Office Action Summary	Application No. 10/591,320	Applicant(s) TSUBOI ET AL.	
	Examiner RYAN DODD	Art Unit 3655

DETAILED ACTION

This is the third office action on the merits for Application Serial Number 10591320, which is a National Stage/371 of PCT/JP04/02737.

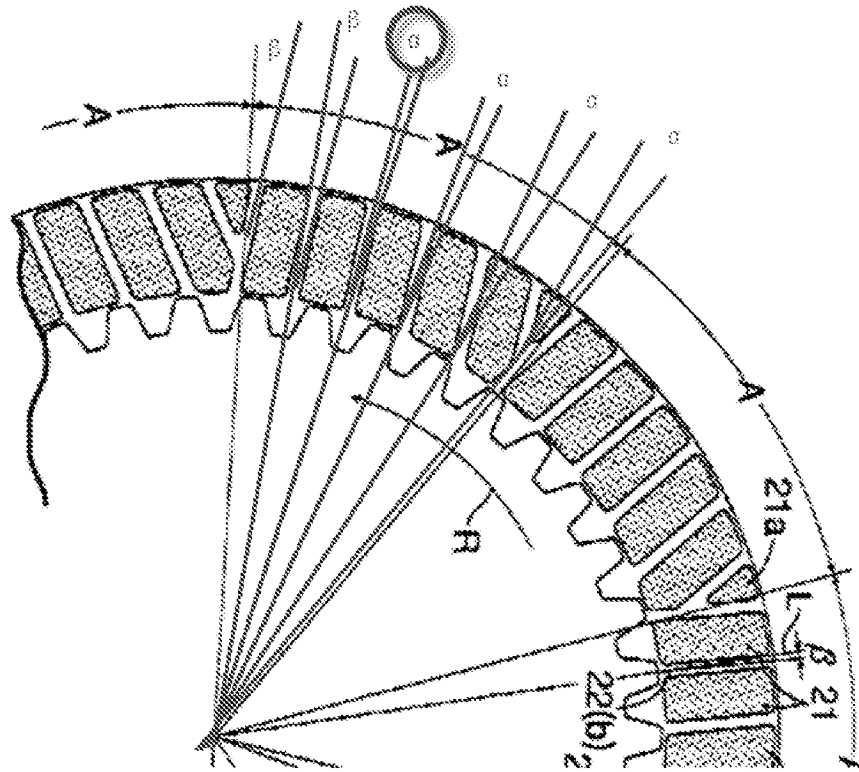
The limitation: “wherein the discharge angle (β) is equal to the inflow angle (α)”, may be interpreted to mean that every angle (β), formed by a radial line (L) of the friction plate passing through and inner end of the discharge oil channel itself (claim 1, lines 11-12), of which there are many (see figure below), is equal to every angle (α), of which there are multiple. Although there are particular angles (β) that may be equal to particular angles (α), the interpretation herein presented is not enabled in such a way as to enable one skilled in the art to make the invention, because every angle (β) is not equal to every angle (α).

Similarly, The limitation: “wherein the discharge angle (β) is less than the inflow angle (α)”, may be interpreted to mean that every angle (β), formed by a radial line (L) of the friction plate passing through and inner end of the discharge oil channel itself (claim 1, lines 11-12), of which there are many (see figure below), is less than every angle (α), of which there are multiple (see figure below). Although there are particular angles (β) that may be less than particular angles (α), the interpretation herein presented is not enabled in such a way as to enable one skilled in the art to make the invention, because every angle (β) is not less than every angle (α).

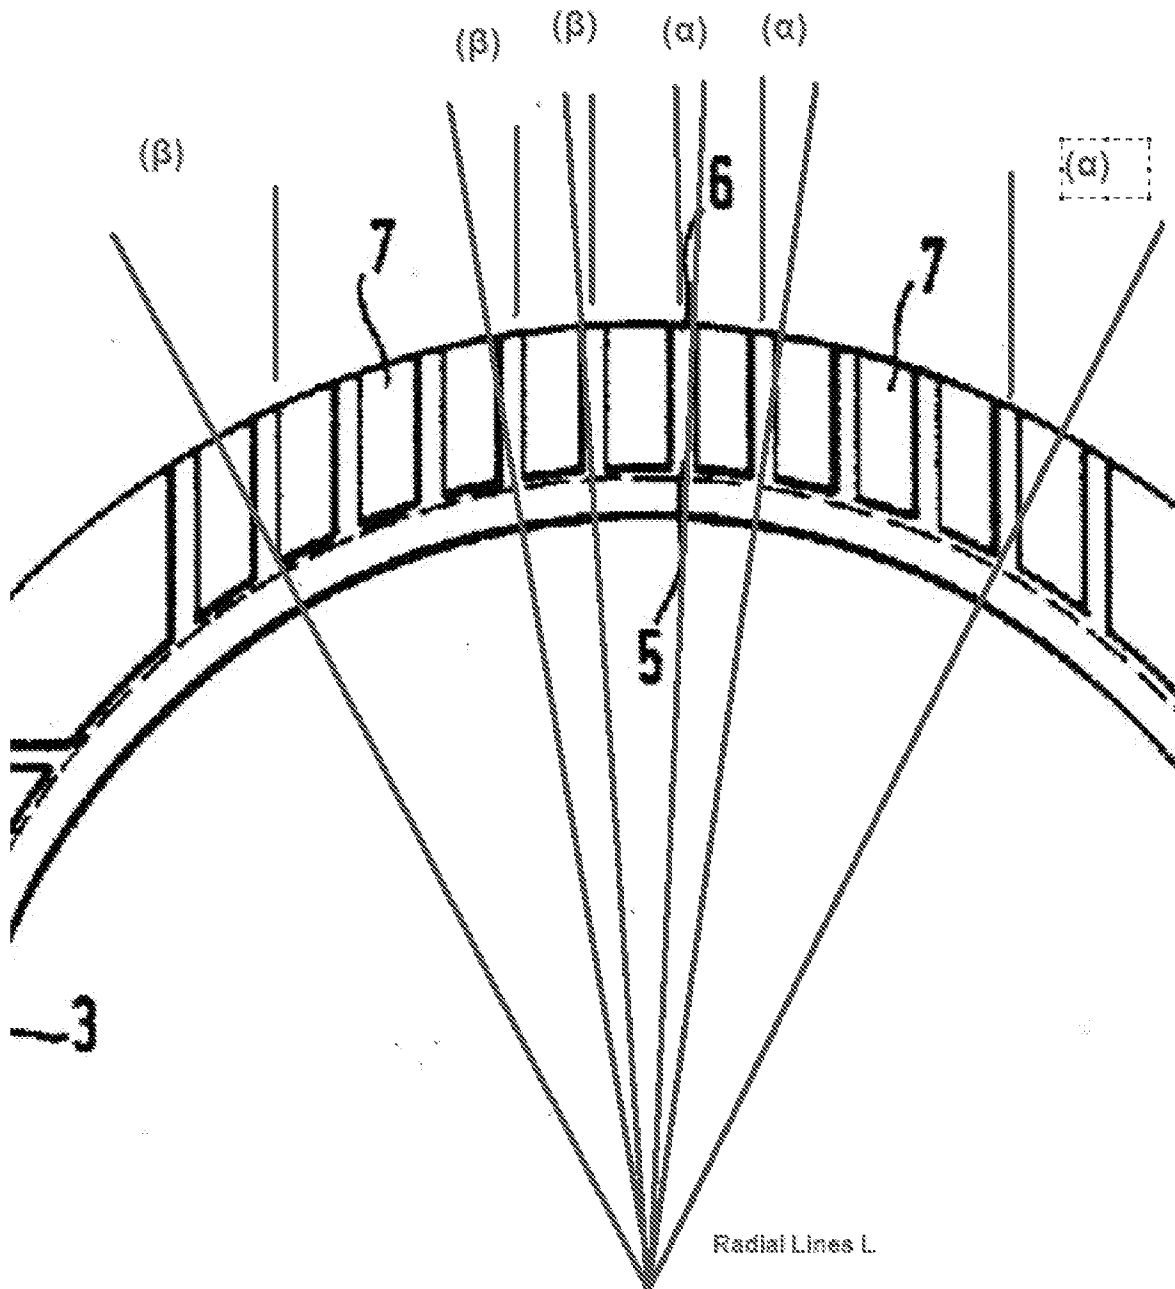
- wherein the plurality of oil channels include a plurality of discharge oil channels having a discharge angle (β) relative to a radial line (L) of the friction plate and which are configured to discharge oil from an inner peripheral side to an outer peripheral side of the friction plate due to a screw pump action that occurs when the friction plate rotates relative to the clutch plate (see Fig. 2, and figure below), and

- the plurality of oil channels further include a plurality of inflow oil channels having an inflow angle (α) relative to the radial line (L) of the friction plate and which are configured to draw oil in from the outer peripheral side to the inner peripheral side of the friction plate due to the screw pump action that occurs when the friction plate rotates relative to the clutch plate (see Fig. 2 and figure below), and

- wherein the discharge angle (β) inclines rearward relative to the radial line (L) and the inflow angle (α) inclines forward relative to the radial line (L) (see Fig. 2, and figure below).

As to **claims 4-9**, as best understood, at least one discharge angle (β) of Bauer '282 is equal to at least one inflow angle (α), and at least one discharge angle is less than at least one inflow angle, as measured from a radial line L (See Fig.2, and figure above).

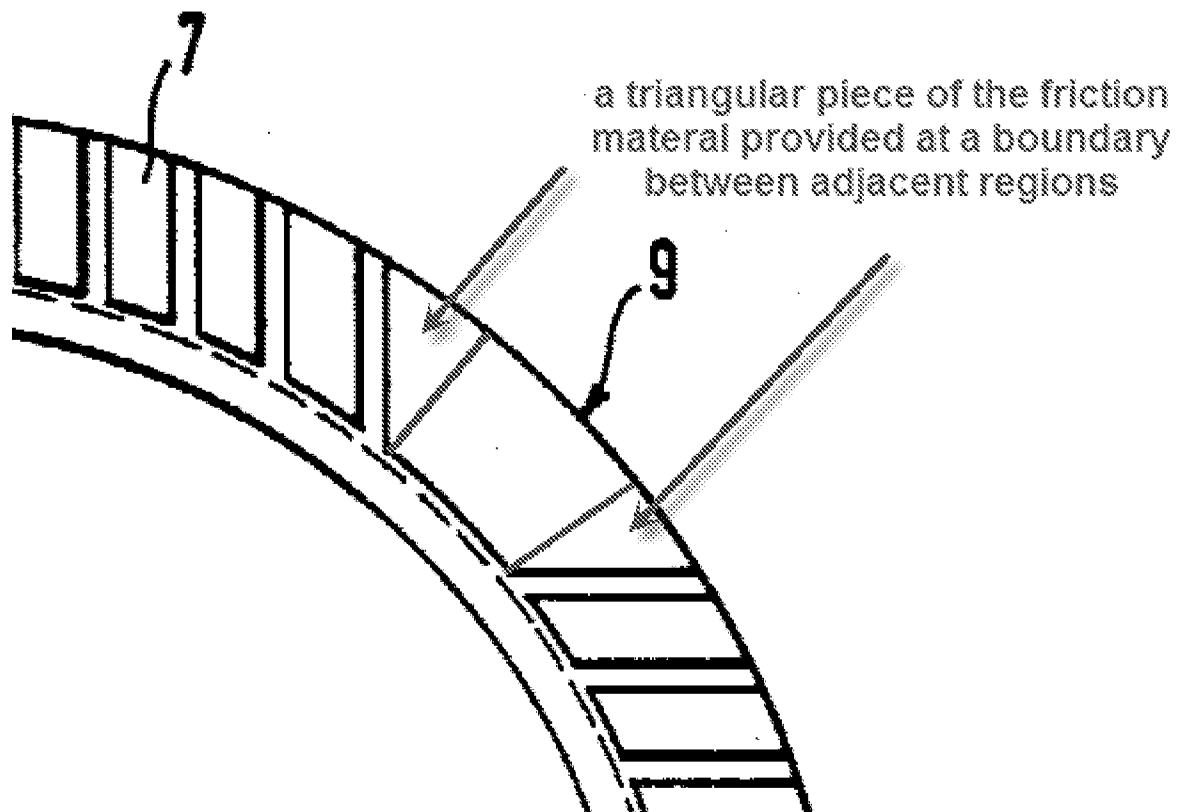
As to **claim 2**, Bauer '282 discloses that the friction plate is divided into a plurality of regions (A) arranged in the peripheral direction, each region including an equal number of discharge and inflow oil channels (for instance in Fig.3 Bauer '282 implies 4 regions).

As to claim 3, Bauer '282 discloses a triangular piece of the friction material that is provided at a boundary defined between adjacent regions (see figure below).
